Division 5.2 and EPBC Act Approval

Modification Assessment

**The Northern Road Upgrade – Mersey Road,
Bringelly to Glenmore Parkway, Glenmore Park**

December 2018

Figure 2-2 Comparison of SPIR and Final EIS and refined construction footprints

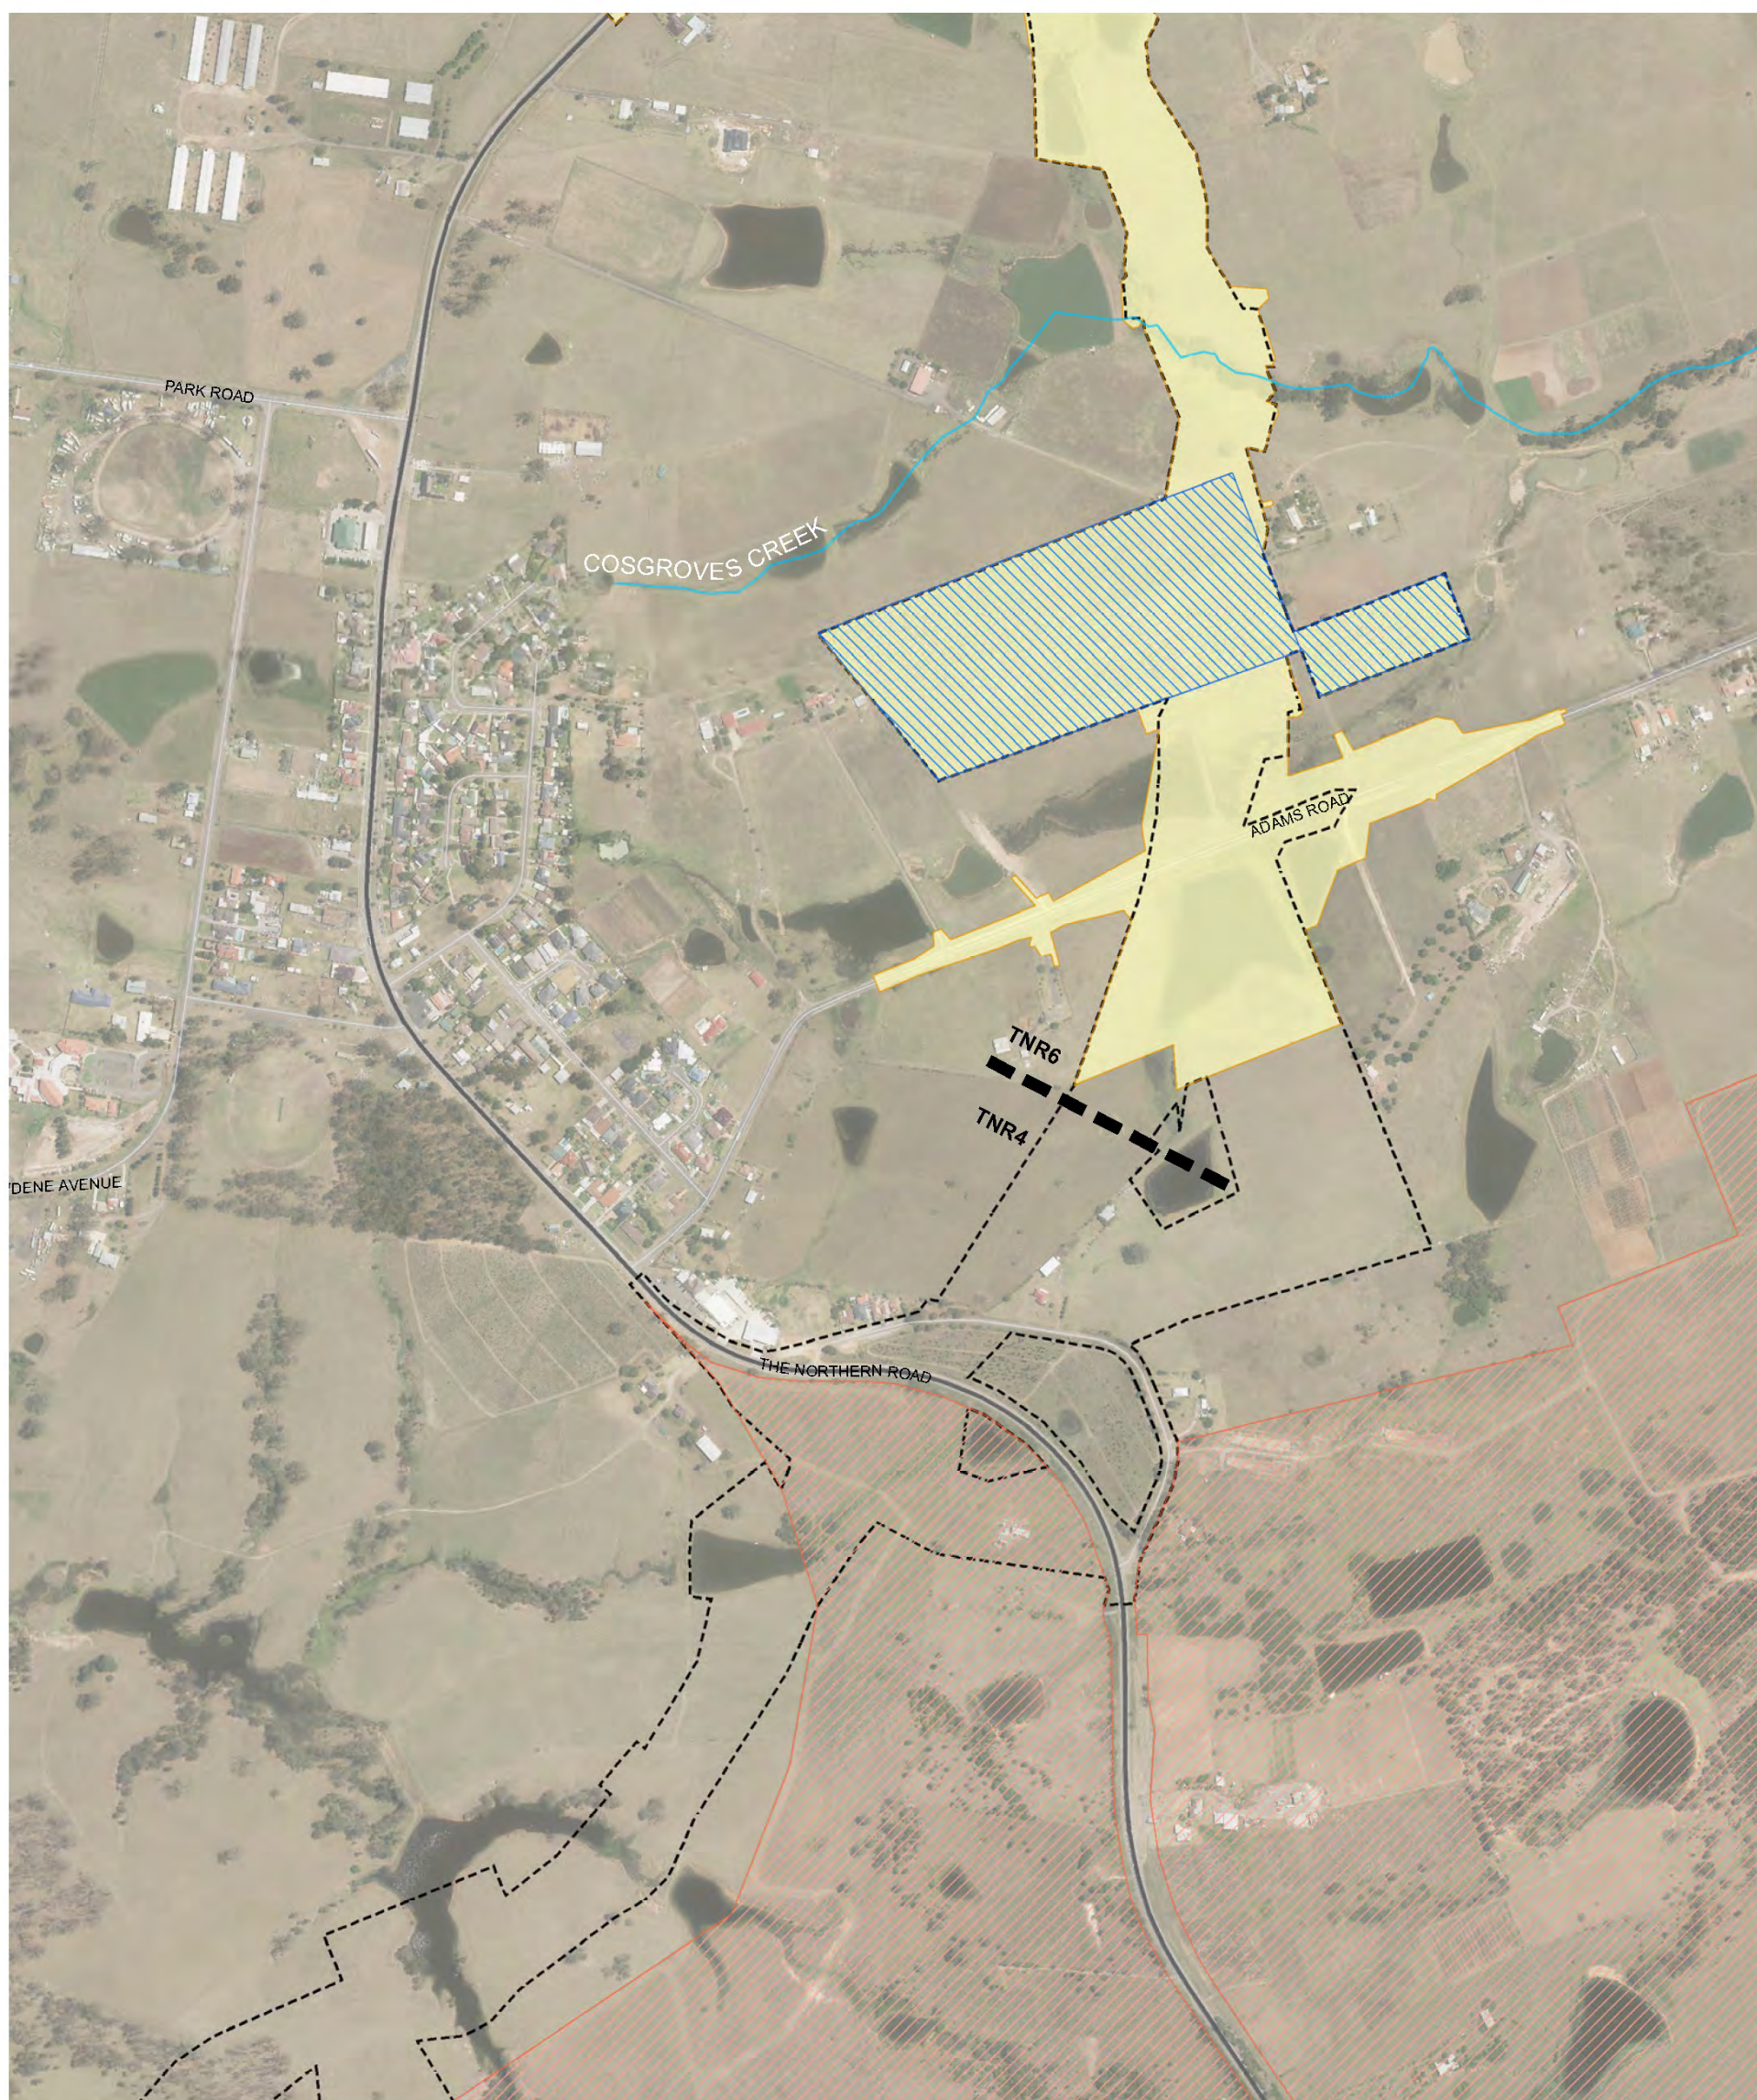
Proposed changes to the approved construction and operational project boundaries are shown in Figure 2-2 and Figure 2-3 and are limited to:

- An increased construction and operational footprint around Adams Road to enable the regrading of this road
- Minor increases to the construction boundary to allow private property access adjustments
- A reduced footprint for the ancillary facility area (and associated construction boundary) at the south-eastern corner of Elizabeth Drive and The Northern Road intersection
- Slight rationalisation (reduction) of the operational boundary at three locations based on the minor vertical, horizontal and cross-section alignment refinements proposed and consultation with affected property owners to reduce and simplify property acquisition.
